**Report Type:** DA Access Report  
**Reference Number:** 19019  
**Client:** Tom Zeaiter Constructions  
**Site Address:** 23-25 Lethbridge Street, St Marys NSW

# ACCESS REPORT

This Access Compliance Report is to accompany a Development Application for the development proposed at 23-25 Lethbridge Street, St Marys

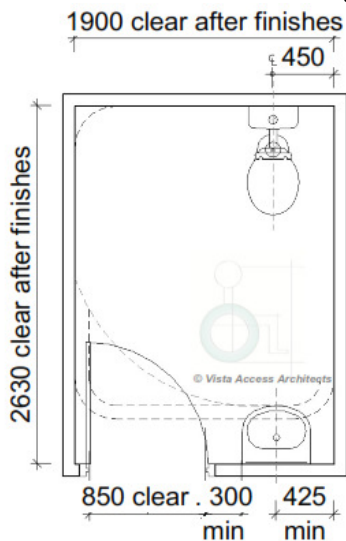
Head heights for both dedicated accessible parking space and the shared zone to be as shown above. No beams, pipes, sprinklers or any other encroachments are permissible for the entire 5.4M width of the dedicated and shared zone as per Section shown above.

The Accessible parking, shared zones, linemarking and bollards to be as shown above. Access symbol is not to be provided when spaces are allocated to Adaptable units.

**Pre-adaptation and Post-adaptation layout shown below.**

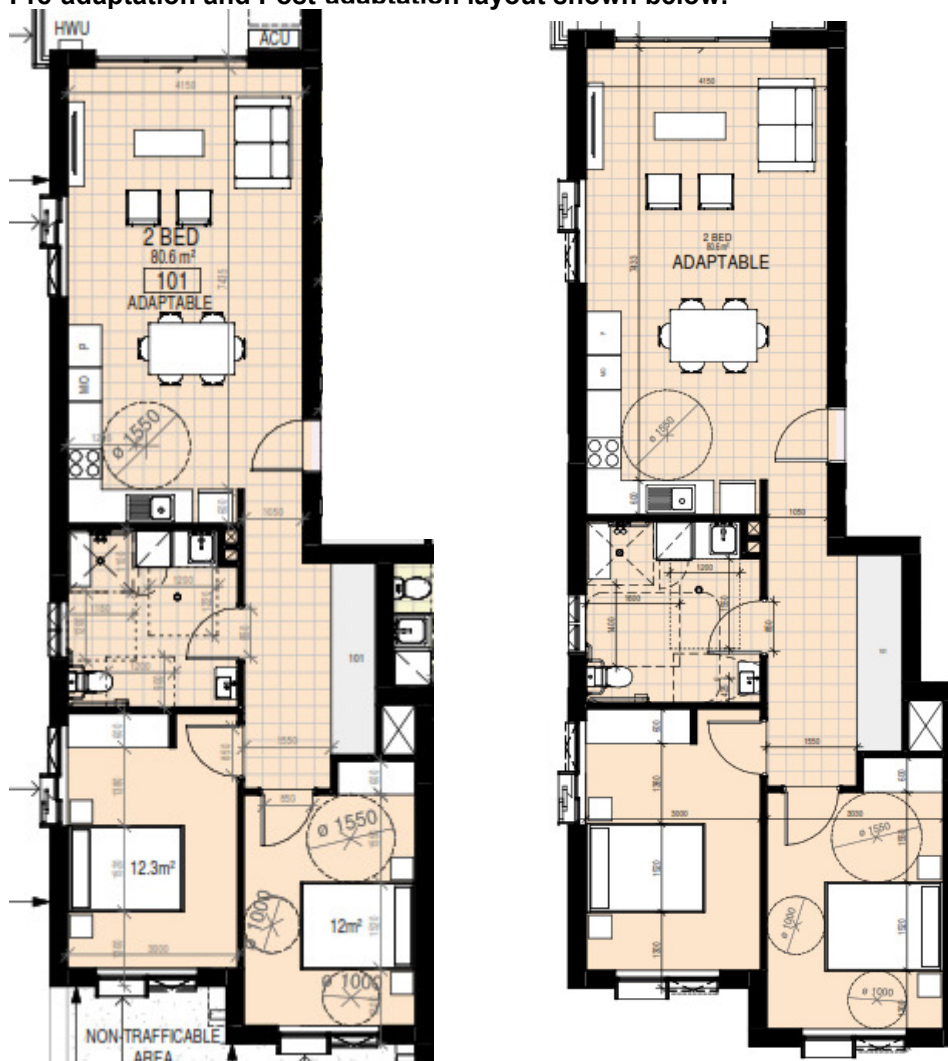
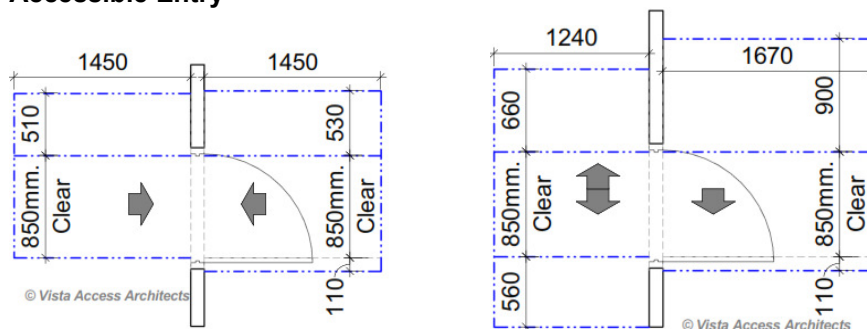
The units designated as adaptable are unit numbers **101, 201 and 301**

At DA stage there is insufficient information to certify compliance with the Standard, however, in accordance with the table below, the nominated units can comply with the spatial requirements of AS4299 for Adaptable Housing.

By incorporating the essential requirements listed Checklist below in the Specifications, the nominated Adaptable units can achieve full compliance with Adaptable House Class C
